**STAFF REPORT
GREENFIELD ZONING BOARD OF APPEALS
THURSDAY, NOVEMBER 19, 2020**

- 1. Roll Call**
- 2. Approval of the minutes from the February 26, 2020 meeting.**
- 3. Approval of the minutes from the October 22, 2020 meeting.**
- 4. Zoning Special Exception petition for construction of two (2) single-family homes, to be located at 4133 & 4141 S. 90 St., submitted by Ryan Janssen, d/b/a Ryan's Buying, LLC. (Tax Key No. 569-1158-001)**

Lot 15 Neighboring Setbacks and Proposed Dwelling Layout

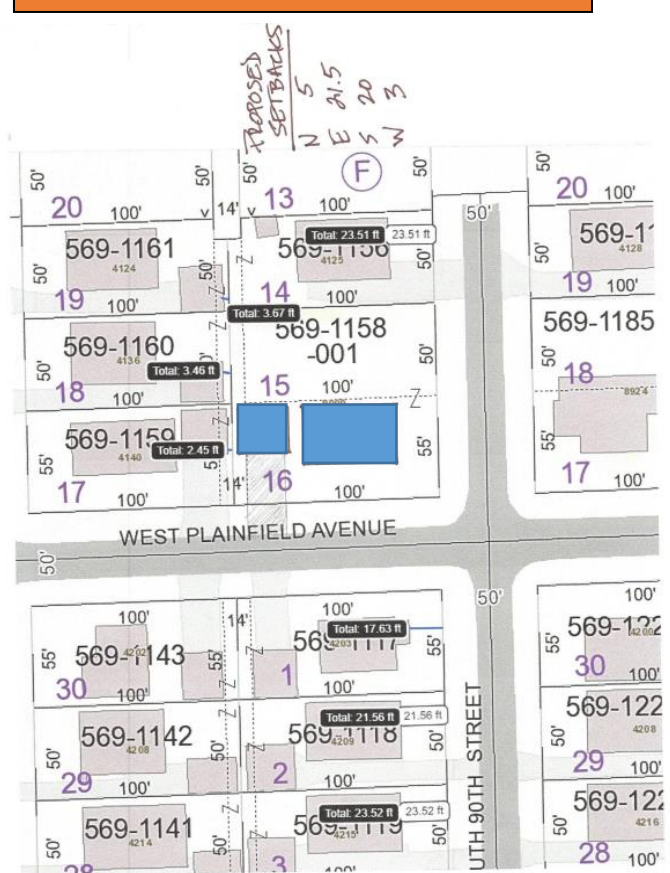
The proposed dwelling on Lot 15 would be constructed with an attached garage in the front. This allows the applicant to build and maintain the side yard and rear yard setback requirements of the R-3 District.

Lot 16 Neighboring Setbacks and Proposed Dwelling Layout

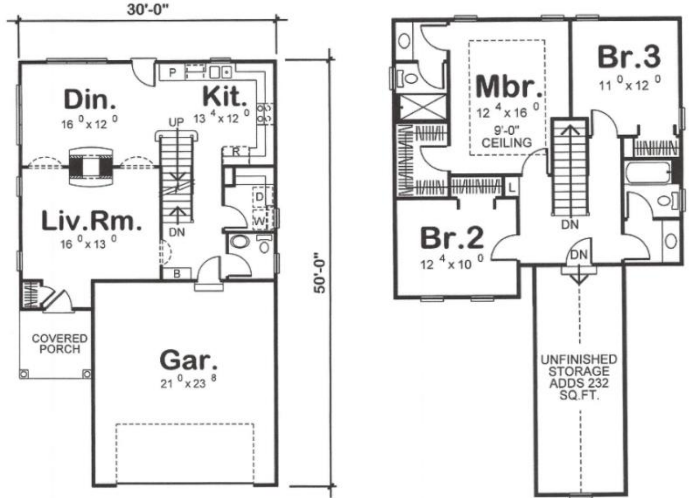
The proposed dwelling on Lot 16 would be constructed with a detached garage with a driveway onto W. Plainfield Ave. The proposed side yard setbacks for the home would meet the R-3 requirements (5 ft. to the north and 20 ft. to the south—it's a corner lot). Mr. Janssen is requesting a rear yard setback variance for the detached garage of three (3) ft. All detached garages in the neighborhood are within feet of the rear or side yard lot lines. Mr. Janssen took the average setback of the garages that are closest to Lot 16 and determined that their setbacks were 3.2 feet.

Lot 16 Proposed Concept

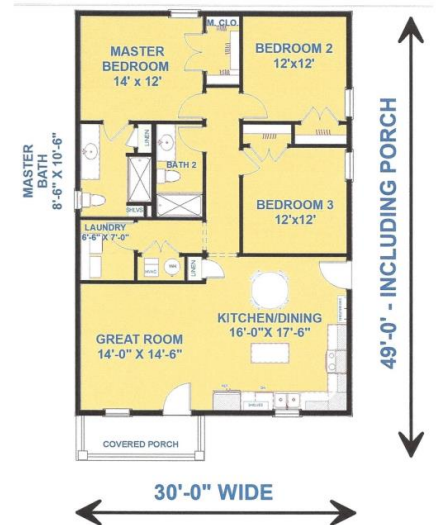
Both homes' architectural design include small front open porches. There are other homes in the neighborhood that have small front open porches that cover the front stoop as these proposed homes do. Staff does not object as the porch adds to the architectural style of the homes.

Staff does not have any objection to the proposed setback, lot coverage ratio, and front porch variance requests, on the basis that the requested setbacks, lot coverage ratio and small front porch/stoop coverings are consistent with surrounding dwellings/parcels, and on the basis that today's R-3 Zoning District regulations are very difficult to meet when constructing a new home on an existing non-conforming parcel. Staff recommends approval.
